Amendments/Additional Information

From: [Helen Webster](#)
To: [Planning](#)
Cc: [Ailsa Teasdale](#)
Subject: FW: NYM/2017/0469/FL - Land on Egton Lane, Glaisdale E03 Access layout 21_08_17 11193
Date: 20 December 2017 16:36:15
Attachments: [D11193-04A.pdf](#)
[D11193-05A.pdf](#)

CLIENT: Mr S Agar			
PROJECT: Extension To Farm Building			
A3	DRN: nid	DATE: Dec 17	
SCALE: As Noted	ISSUE: PROVISIONAL

DRAWING TITLE: Access Layout EXISTING	
DRAWING NR: D11163-04	REV: A

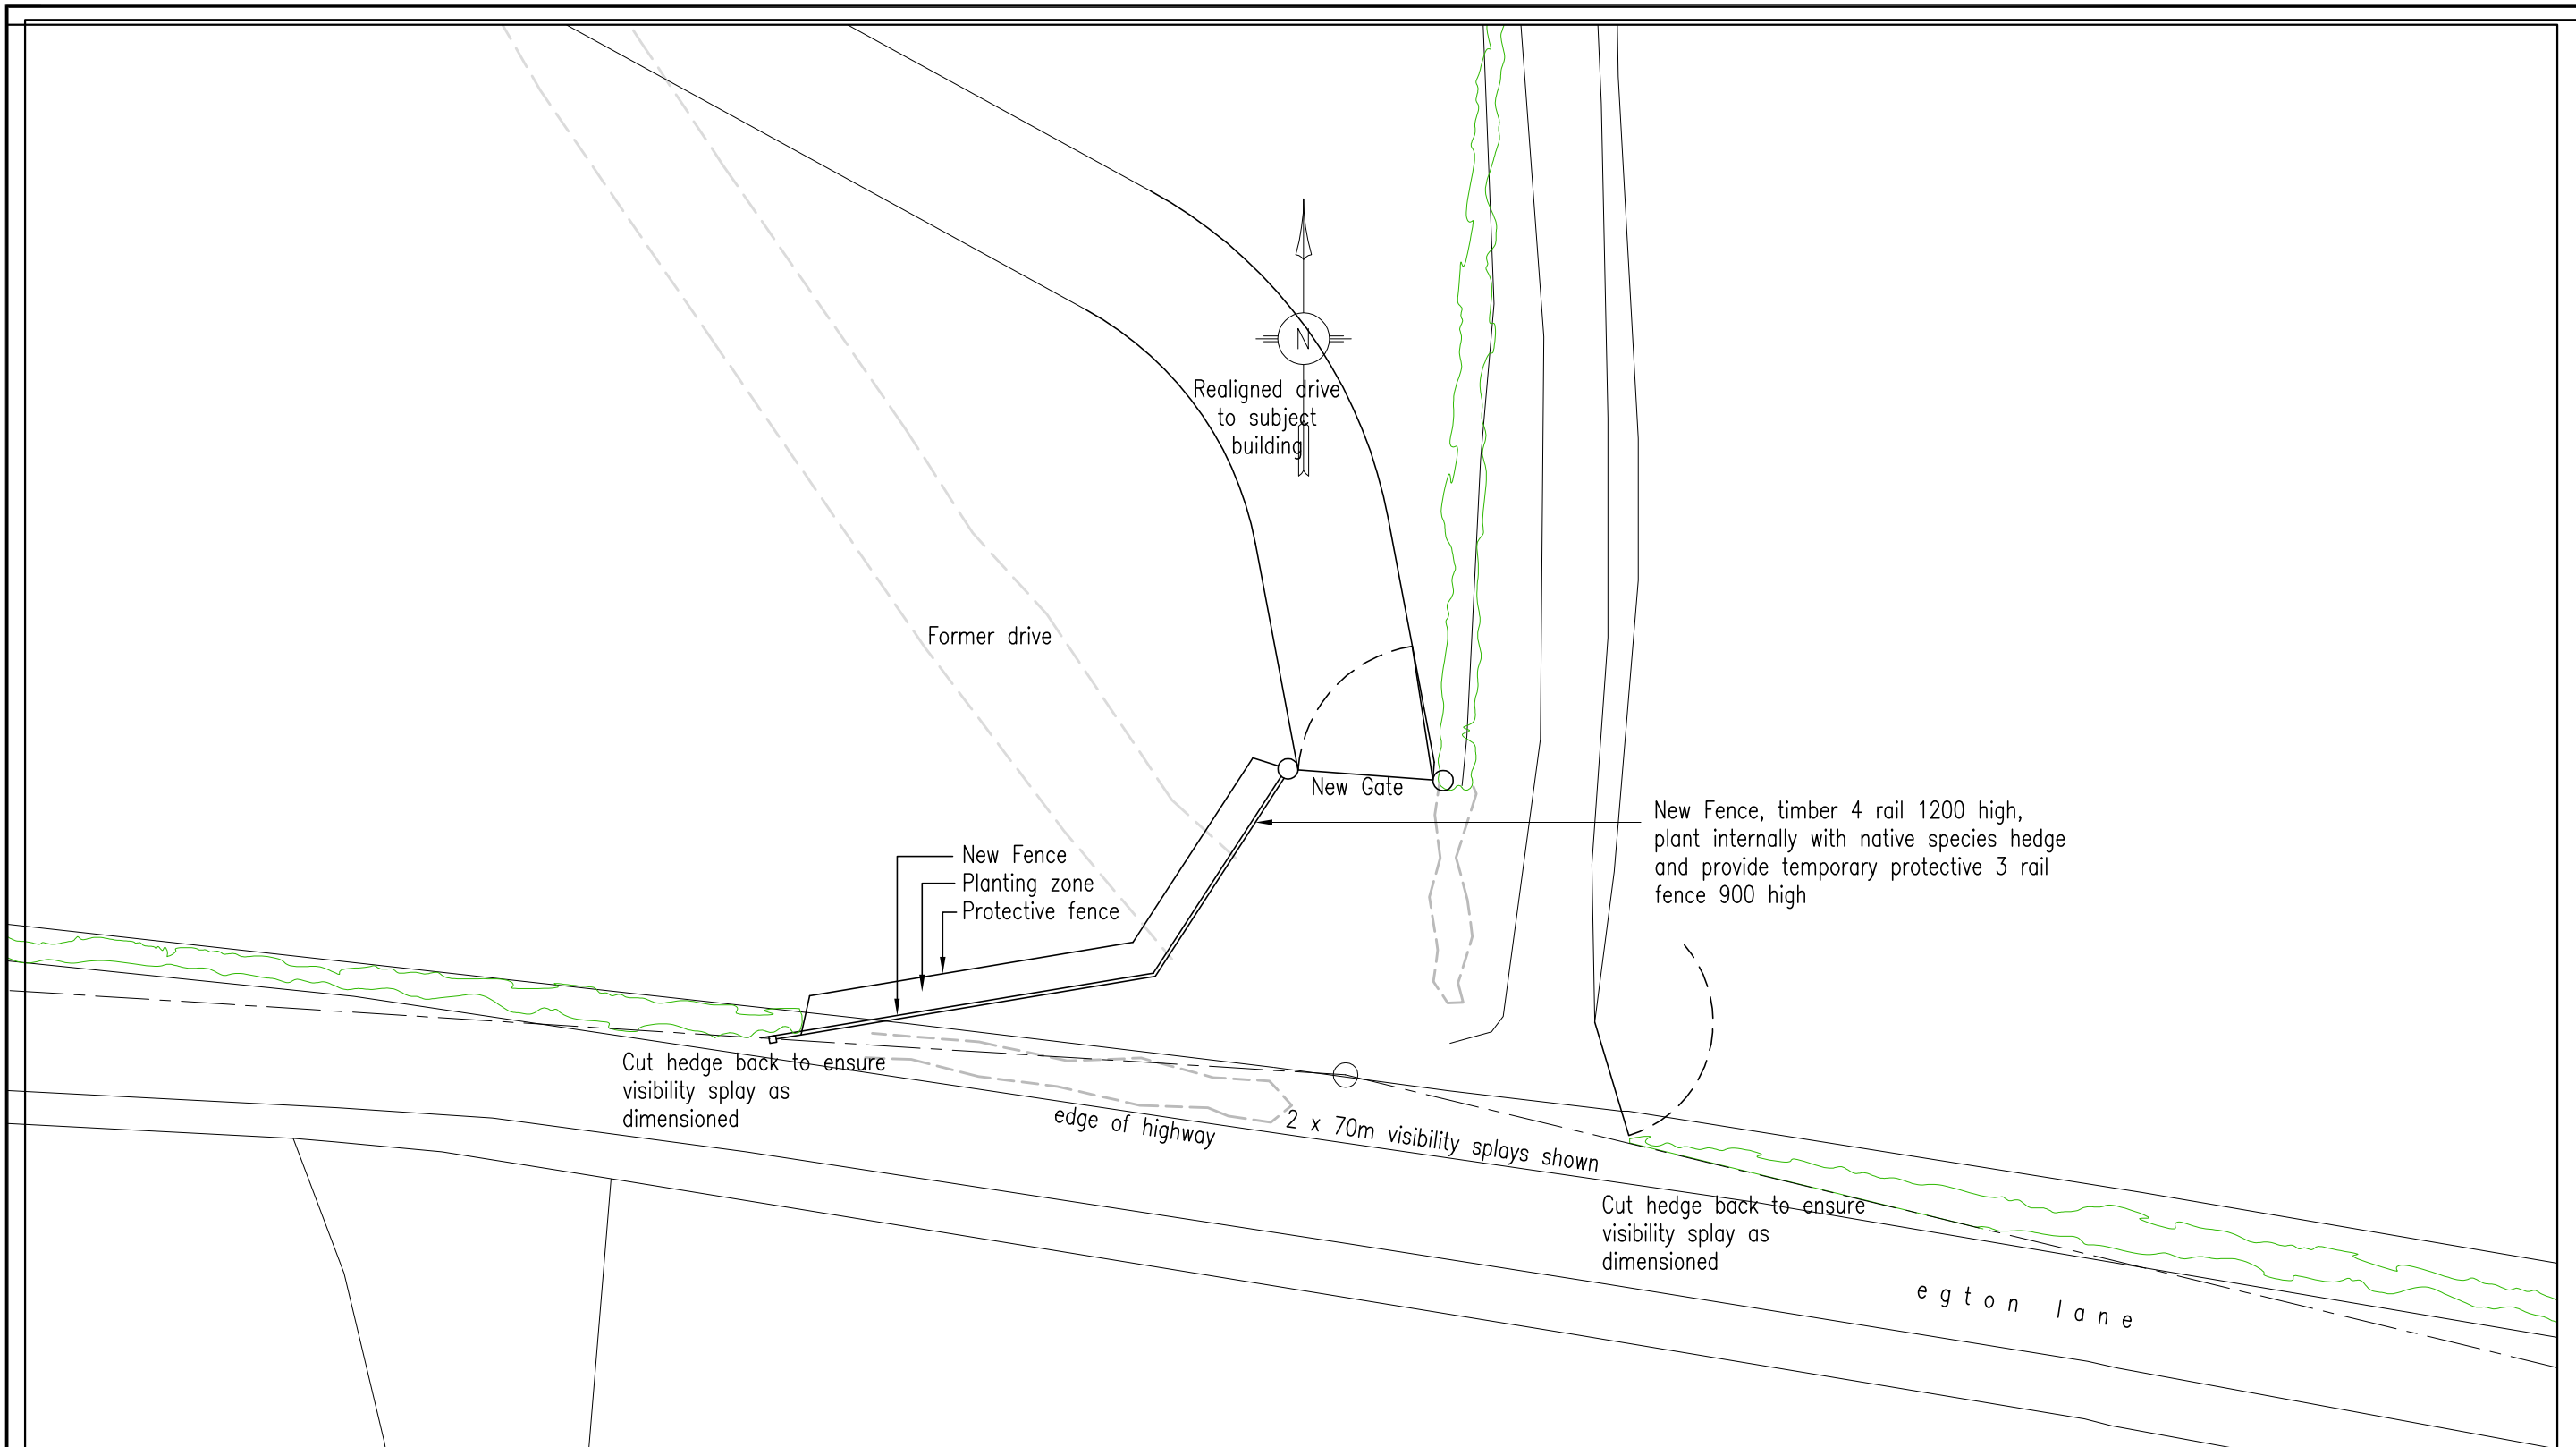
Sorry for the delay but I now attach drawings D11193-04A and 05A showing the existing and proposed layouts for the entrance.

These have been produced showing substantial improvements following a meeting on site between the client and Ged Lyth who is copied in. Ged confirmed the verge crossing will need to be carried out by a contractor licensed to work on the highway.

- Negligible increase in vehicular movement. More material, food etc will be stored on site in the larger building
- Animal husbandry will improve due to more cover
- The alterations will improve vehicular access and movement from the existing poor situation
